UNITED STATES PATENT AND TRADEMARK OFFICE

APPLICATION NO.	FILING DATE	FIRST NAMED INVENTOR	ATTORNEY DOCKET NO.	CONFIRMATION NO.
10/674,198	09/29/2003	James Patrick Clinch	140/40652/O&T 975	2676

Office Action Summary

DETAILED ACTION

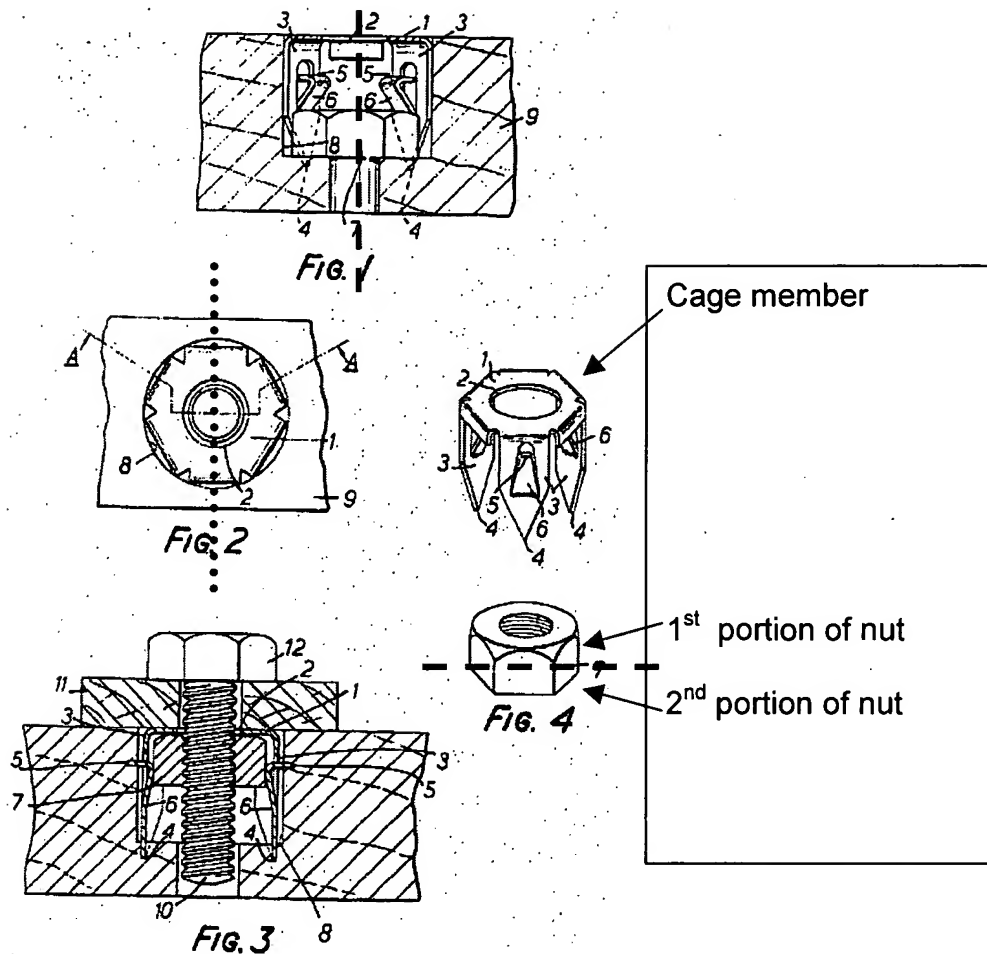
Re claims 1 and 10: Parkin teaches a cage member (upper item in Fig 4) engageable with nut 7 having first and second portions and an aperture extending at least partially therethrough, (note that applicant is not claiming the nut, and a nut is capable of having distinct first and second portions. **However, further regarding claim 10**, the nut of Parkin can be considered to have a 1st portion [upper section in the figures, having the tapered sides] and a 2nd portion [lower section without taper]) thereby providing a cage nut assembly, said cage member comprising:

Said body defining a base portion (1) and at least one wall portion (3) and configured to engage the nut first portion such that the nut second portion does not come into contact with either the base or said at least one wall (Fig 1- notice that neither portion of the nut contacts the base or at least one wall, and in Fig 3, the 2nd portion does not contact the base or a wall 3), said body provides a limited range of nut movement in at least one dimension (axially along what could be called the bolt axis - see dashed line by examiner in Fig 1 above, although there is slight radial movement

Re claims 2-3, 5, 11-12,14: Said upper portion comprises at least one arm (6). Looking at Fig 2, note that there are at least two arm portions (6) which are positioned on opposite sides of a plane that bisects the base (see Fig 2 and examiner-drawn dotted line for plane), thus they are positioned opposite one another. The arms define an opening sized to receive the nut member therethrough when the nut 1st portion is engaged by said 2 arm portions (See Fig 3). Examiner notes that applicant did not require the arm to extend **directly** from said base.

Re claims 6,15: Fig 1 shows each arm 6 with a generally "C" shaped portion, and forming an opening between opposite arms.

Re claims 7,19: Looking at the difference in arm 6 between Fig 1 and Fig 3, it is clear that it is inherently flexible.

Re claims 8,20: As best understood, at least one arm portion can be moved (see Fig 1 and 3 comparison of arm for movement) to allow the 2nd portion of the nut member to be positioned above said base (entire nut is always above said base). Nut is between at least one wall portion of said body and something - an opposite wall.

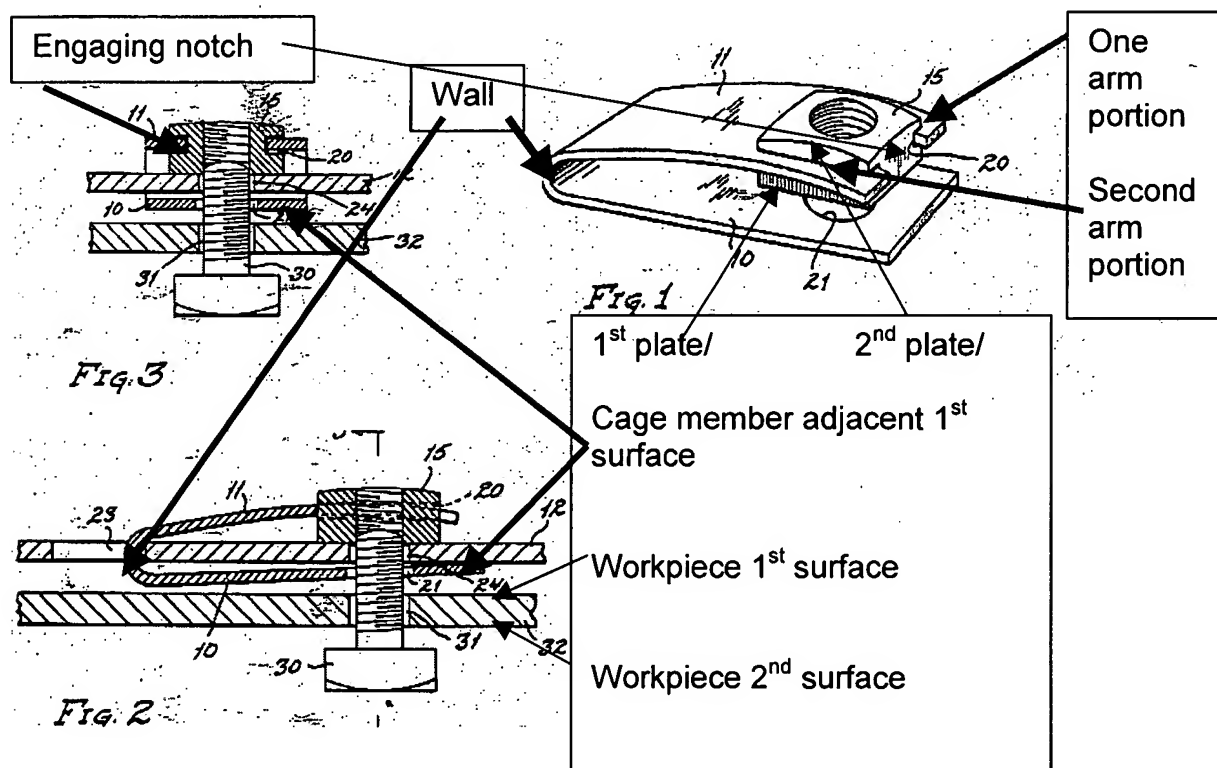
Re claims 1,2,3, 7,8,10,11,12,19,20: Tinnerman 342 in Figs 1-3 teaches a cage member and nut assembly, said nut (15) having a 1st and 2nd portion (see marked up

drawings below) enclosed by a cage member (10/11) which has a body configured to engage the nut member such that the nut member is encaged. The cage further comprises a body (11/10), and "11" is considered the upper cage/arm portion, and "10" is the base. The wall is labeled by examiner in drawings below. The nut engagement is such that the 2nd portion (same as the portion labeled "1st plate" below - looking at the drawings as oriented, it is the "lower" part of nut below "11") of the nut does not come into contact with either the base or the wall. Figs 1 and 3 shows a limited range of motion in at least one dimension. The body provides a limited range of nut movement in at least one dimension (axially along what could be called the bolt axis - although there is slight radial movement also).

Further Re claims 3 and 12: As shown in Fig 1, arm portion 11 forms two arm portions at the end as labeled by examiner in drawings below. These two arms are opposite each other.

Further Re claims 8 and 20: As best understood by examiner, the at least one arm 11 can be moved to allow nut 2nd portion to be positioned over base and between the wall and something - in this case the very end extension of the arm 11 past the notch.

Re claims 22 and 29-30 and 34-35 and 39-42: Tinnerman '342 in Figs. 1-3 teaches a nut (15) enclosed by a cage member (10/11) which has a body configured to engage the nut member such that the nut member is encaged. (Fig 1 and 2) "11" is considered the upper cage portion, and engaging notch (best shown in Fig 1 and 3) will inherently serve to suspend the nut off the base.

Further, the upper portion (arm 11) of said cage member is configured to engage said nut member 15 and is configured to be flexed downwardly by said nut member toward said base portion 10 in order to allow said nut member to contact said base portion (Fig 2). Examiner notes that applicant did not claim direct contact, and it is in contact via contact with intermediate member 12. Fig 2 shows the combination including

Re claim 32,37: The body further comprises at least one wall (see label by examiner above), and Figs 1- 3 show the nut engaged such that the nut does not contact at least one wall.
